Section 4

Responses to Written Comments on the Draft EIR

1. Lisa Carboni, District Branch Chief, California Department of Transportation, District 4 (letter dated November 5, 2008)

East Contra Costa BART Extension (known as eBART) - Draft Environmental Impact Report (DEIR)

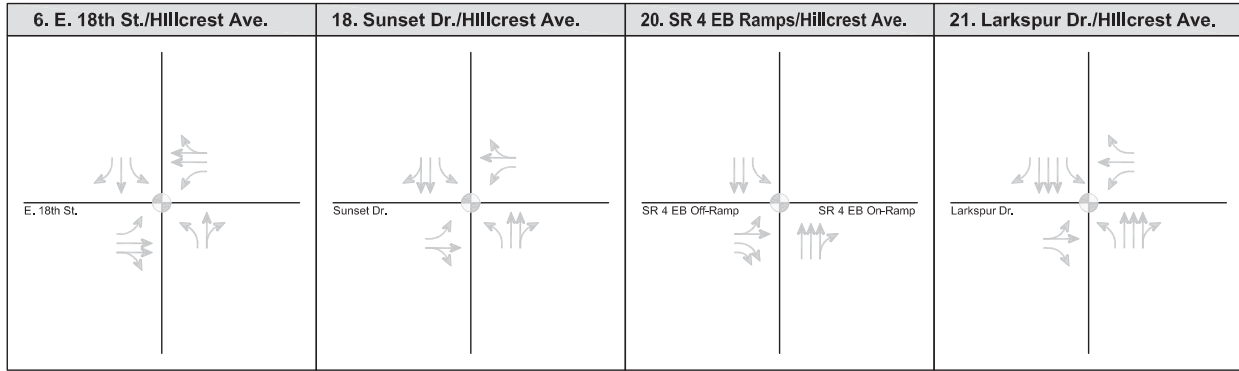
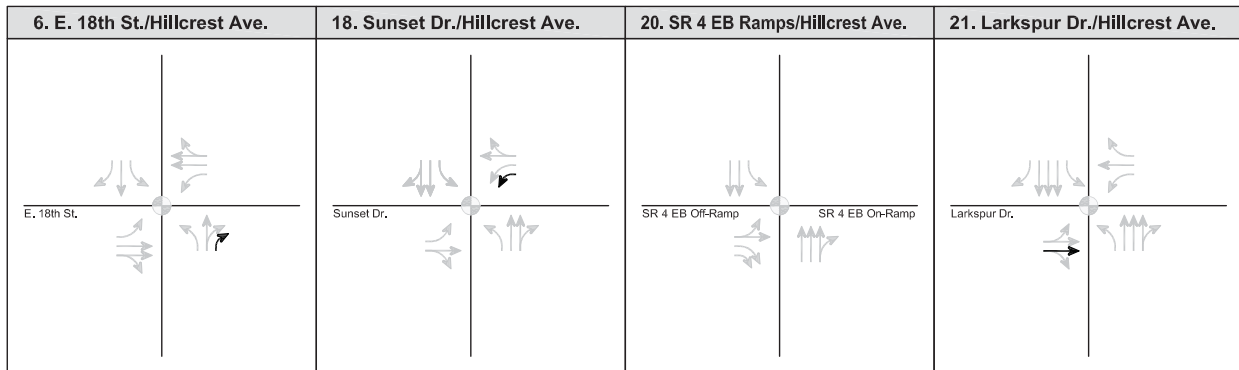
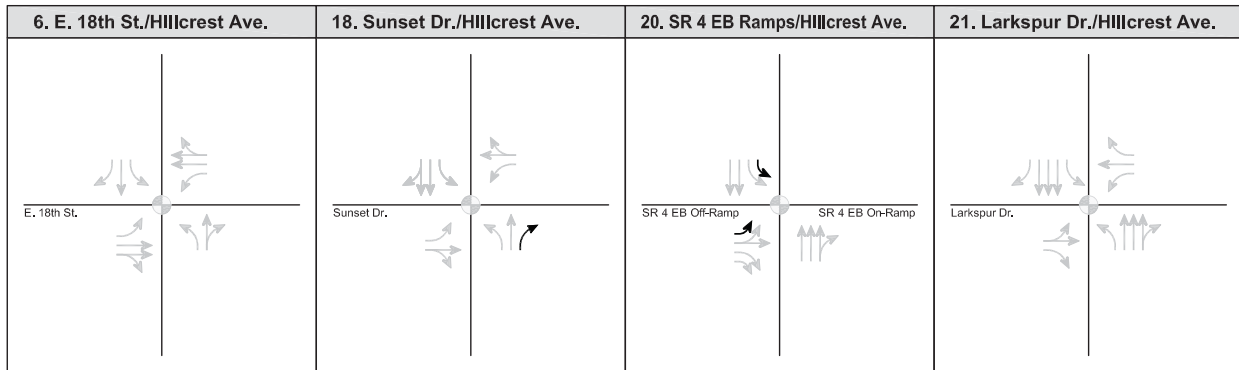
- Page 3.2-76: We would like to see the queue lengths as part of the ramp intersection analyses. We are concerned about the queue length and impact to upstream facilities. Please provide additional information from the SR 4 Railroad Avenue and Hillcrest Avenue Interchange ramp intersection analysis regarding queuing for all scenarios (with and without the Proposed Project, Years 2015 and 2030 respectively).

For the queuing analysis, adjustments were made to the signal timings and simulation settings in Synchro, including mandatory and positioning distances, in order to model more realistic flows. Signal timing adjustments were made in conjunction with assumptions described later in Response 1.32.

The queuing analysis indicated that queues under both AM and PM peak hour conditions dissipate fairly quickly, and that Proposed Project conditions are operationally better than No Project conditions for most locations under both Year 2015 and Year 2030 scenarios. Also, traffic operations are better under Year 2030 scenarios compared to Year 2015 primarily due to the planned reconfiguration of the Hillcrest Avenue interchange. The analysis also suggests that a substantial reduction of the queuing on the SR 4 Eastbound Ramp/Hillcrest Avenue could be accomplished through signal timing and coordination improvements along the Hillcrest Avenue corridor and in the area of the interchange. However, this intersection would remain at unacceptable levels of congestion.

HILLCREST AVENUE STATION AREA INTERSECTIONS - 2030 NO PROJECT CONDITIONS
FIGURE 3.2-14

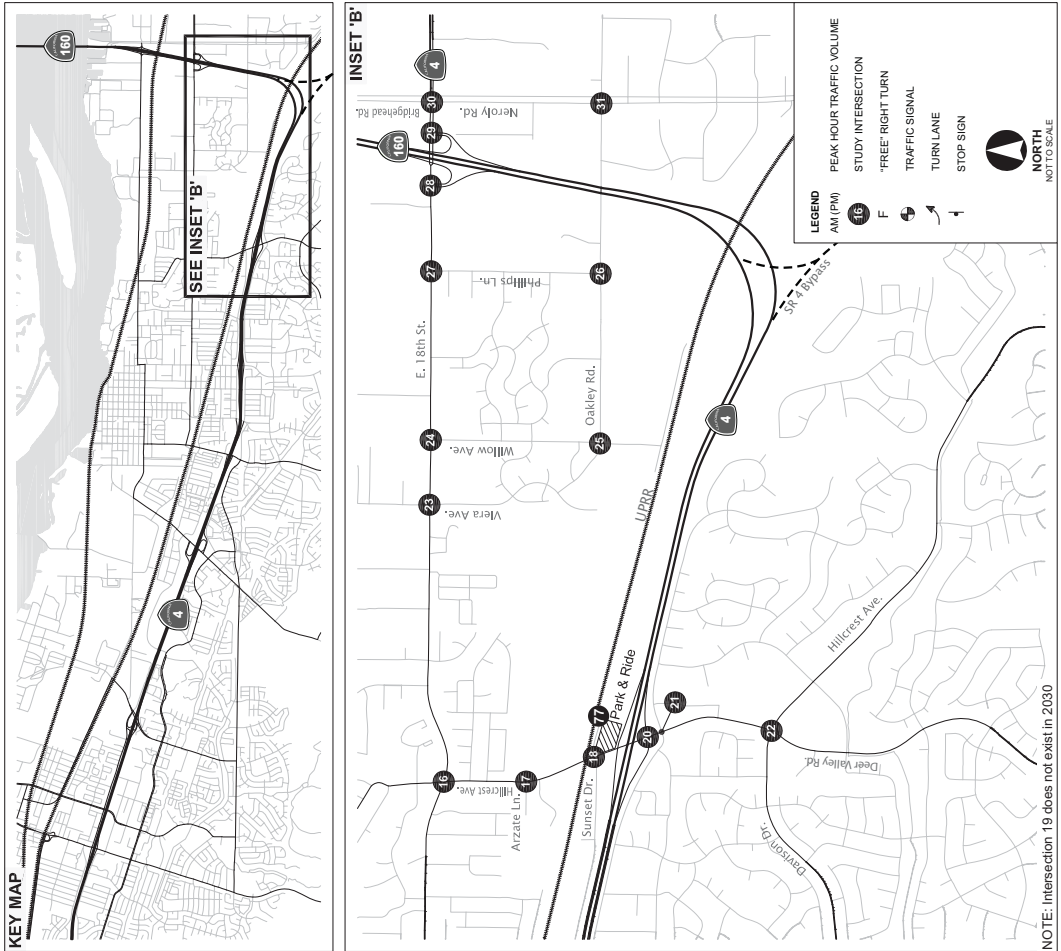
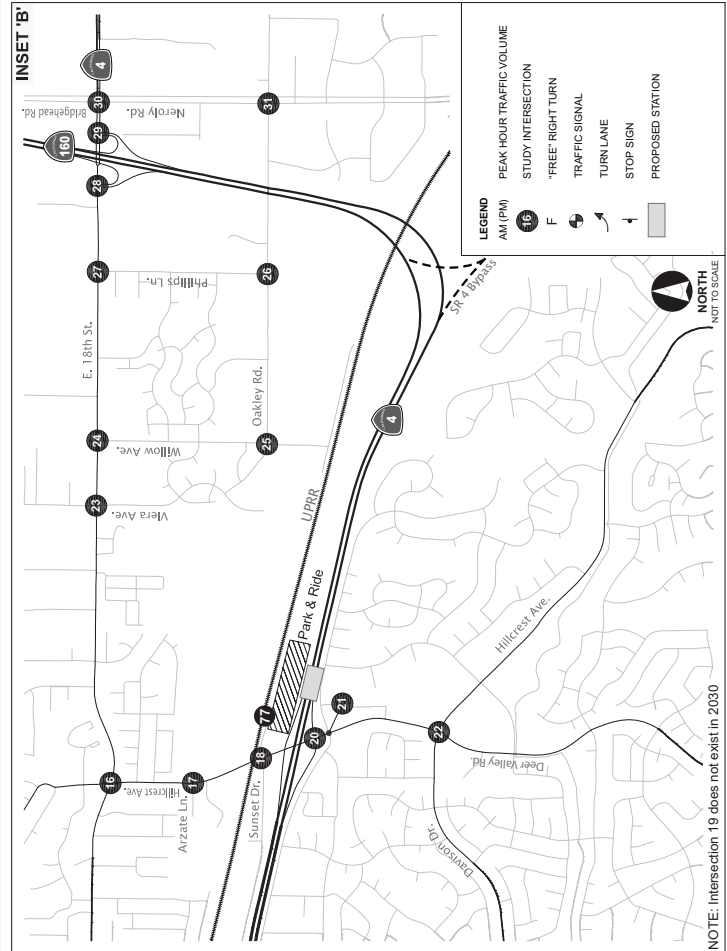
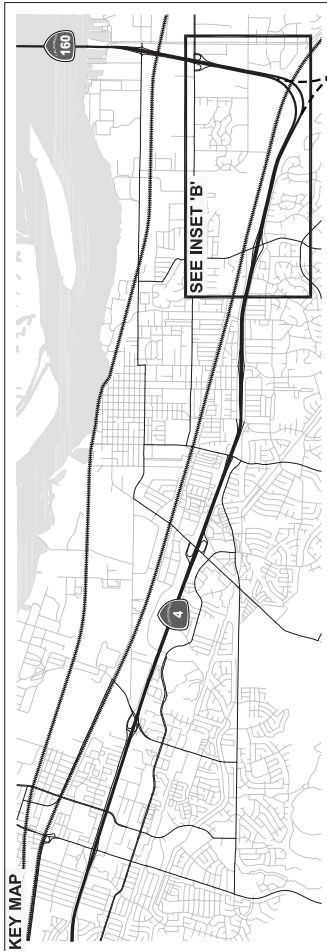
- 1-15
- Page 3.2-76 (Figure 3.2-18 "Hillcrest Ave Station Area Intersection- 2030 Proposed Project Conditions"): Please include the westbound State Route (SR) 4 ramp intersection at Sunset Drive.

- 1.7 The Transportation Technical Report has been revised to include figures showing the additional trips generated by the Proposed Project for the Year 2015 and 2030 scenarios.
- 1.8 The information for the intersection of the westbound ramp to Hillcrest Avenue and Sunset Drive is available and has been added to the tables and diagrams in the Draft EIR. This is a new intersection that will exist after the planned improvements to the Hillcrest Avenue interchange are completed. These improvements are expected to occur after the Year 2015, so this intersection would not appear as part of the Year 2015 analysis but as part of the Year 2030 analysis. The first two paragraphs on page 3.2-43 of the Draft EIR are revised as follows to acknowledge changes to local roadways and intersections:

Table 3.2-18 (2030 AM conditions, pages 3.2-77–78), Table 3.2-19 (2030 PM conditions, pages 3.2-79–80), Figure 3.2-10 (Hillcrest Avenue Station Area – Future Intersection Geometrics), Figure 3.2-14 (2030 No Project, page 3.2-55), and Figure 3.2-18 (2030 Proposed Project, page 3.2-75) have been updated accordingly.

- 1.15 The information for the intersection of the westbound ramp from SR 4 to Hillcrest Avenue and Sunset Drive is available and it is added to the tables and diagrams in the Draft EIR. Please refer to Response 1.8 above which presents the revised text, tables, and figures.

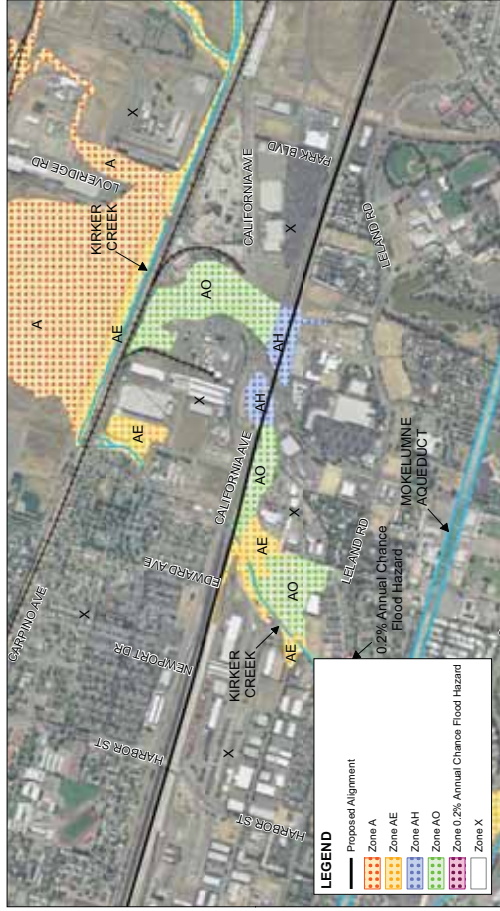
- 1-67 ● Only Zone AE was identified on Figure 3.8-2. The text on page 3.8-7 describes four zones. Please identify all referenced zones in Figure 3.8-2

- 1.67 The comment refers to Figure 3.8-2 of the Draft EIR and whether other flood zones should be mapped. In response to the comment, Figure 3.8-2 is revised to include all flood zones (*Zone X, Zone A, Zone AH, Zone AE, Zone AO, and 0.2-percent-annual chance of flood Zone*), referenced in the text on page 3.8-7 of the Draft EIR. It should be noted that the flood zone limits have changed since the Draft EIR was published. Definitions of the flood hazard zones have been updated and text on page 3.8-7 of the Draft EIR is revised as follows:

Figure 3.8-2 and Figure 3.8-3 have been updated based on a preliminary Digital Flood Insurance Rate Map (DFIRM), dated October 24, 2008 (which was after the release of the Draft EIR in September 2008). The DFIRM will become effective June 16, 2009. As depicted in the revised Figure 3.8-3, East Antioch Creek floodplain would not cross eBART facilities in the vicinity of SR 4/SR 160 interchange. Therefore, impacts would be reduced regarding flood hazards in this area. Impact HY-10 on page 3.8-34 of the Draft EIR is revised as follows:

FLOOD HAZARDS IN THE HILLCREST STATION AREA
FIGURE 3.8-3

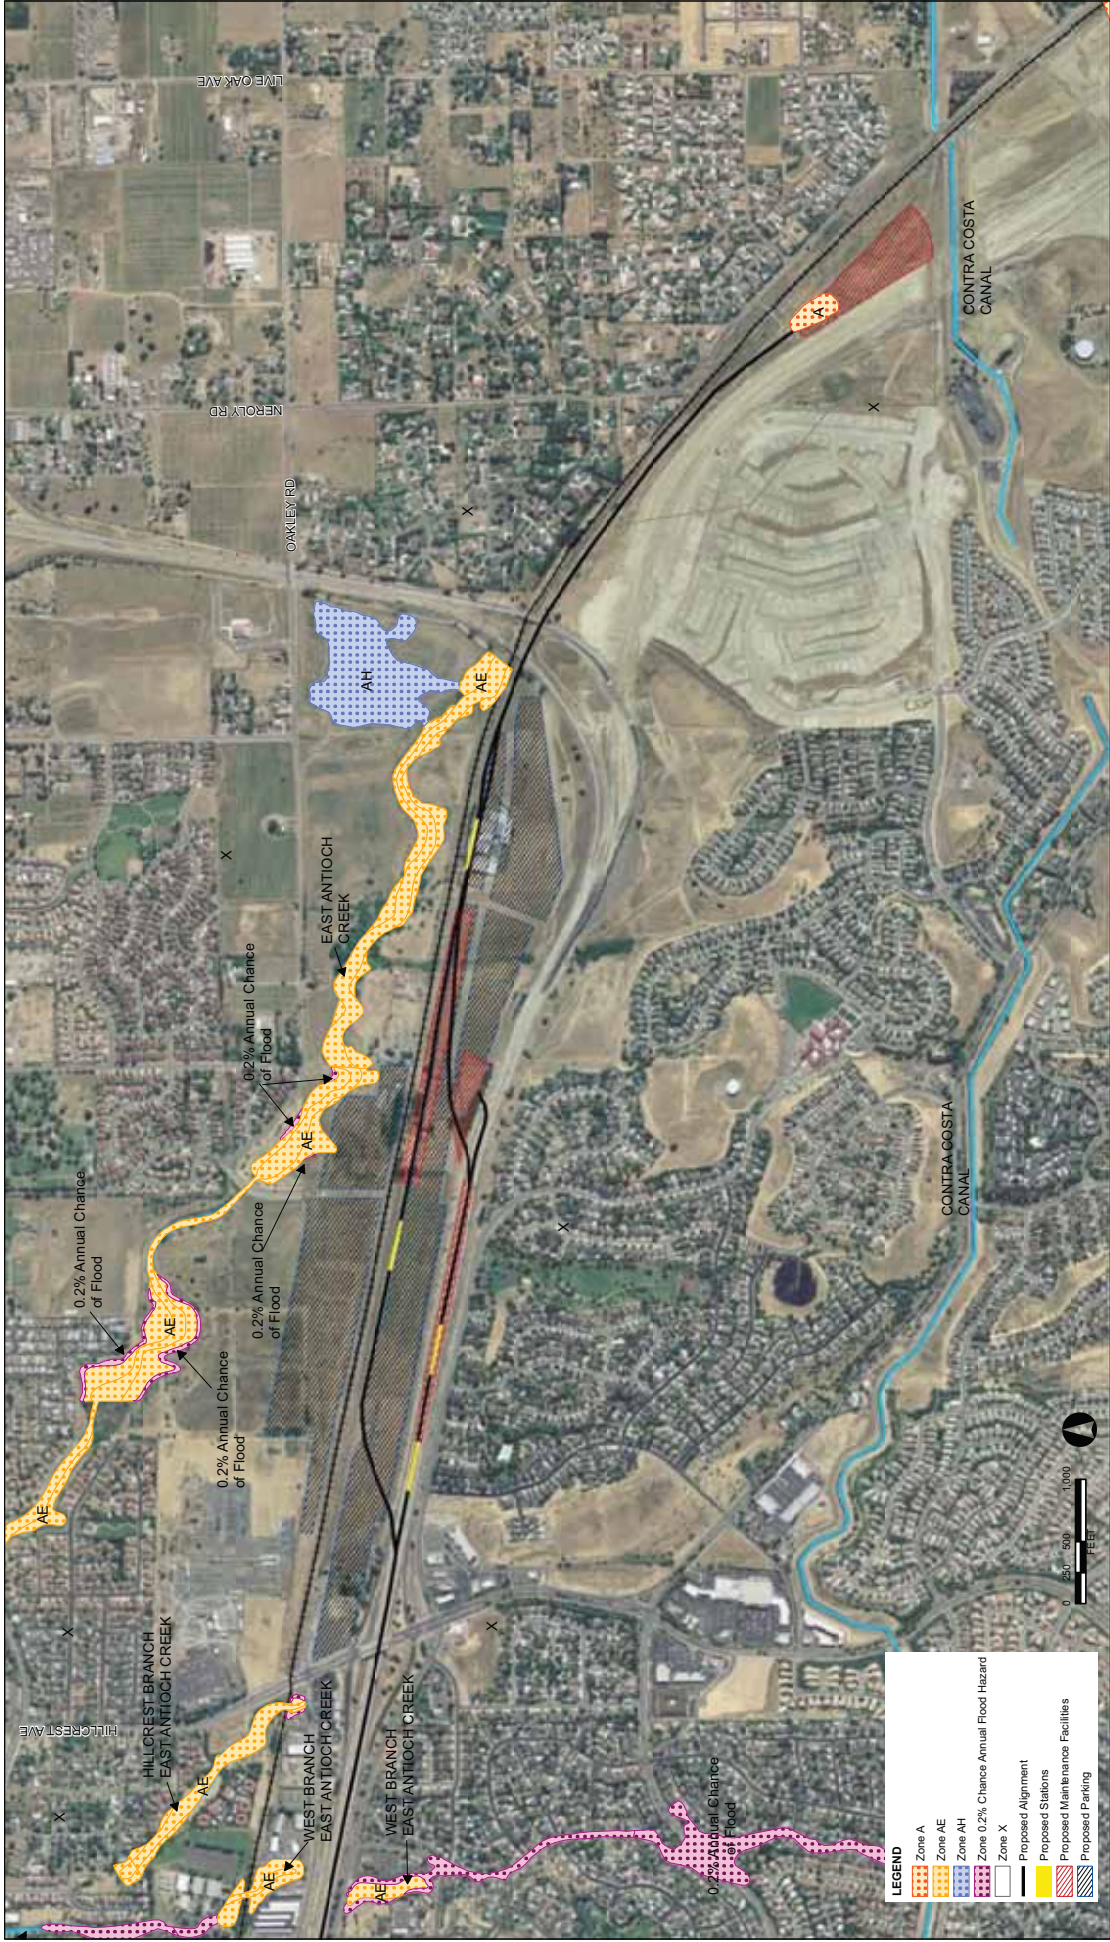
- 1-70 • Page 3.8-8, paragraph 1: Some of the drainage facilities that lie within the project corridor are under the Department's jurisdiction.
- 1-71 • Figure 3.8-9 shows proposed tracks that connect to the proposed remote maintenance facility (Northside East Station Option) crossing SR 160 in the vicinity of the east branch of the East Antioch Creek. The Department may improve this cross culvert in the future. The eBART DEIR should reflect this fact.

- 1.71 The comment refers to possible future improvements to the cross culvert, in the vicinity of the east branch of the East Antioch Creek. However, updated floodplain mapping illustrated in revised Figure 3.8-3 shows that the East Antioch Creek flooding no longer extends south of the SR 4 bypass (see Response 1.67 above). In response to the comment, the second paragraph of Impact HY-CU-15 on page 3.8-40 of the Draft EIR is revised as follows:

- 1.78 Please refer to Response 1.71, above. Per the revisions to Figure 3.8-3, no eBART facilities would cross East Antioch Creek floodplain. Therefore, the eBART project would cross the following floodplains: Kirker Creek/Old Kirker Creek, Los Medanos, Markley Creek, and West Antioch Creek.
- 1.79 BART will comply with Caltran's procedures for applying for an encroachment permit, including the description of traffic-related mitigation measures that will be incorporated into the construction plans.
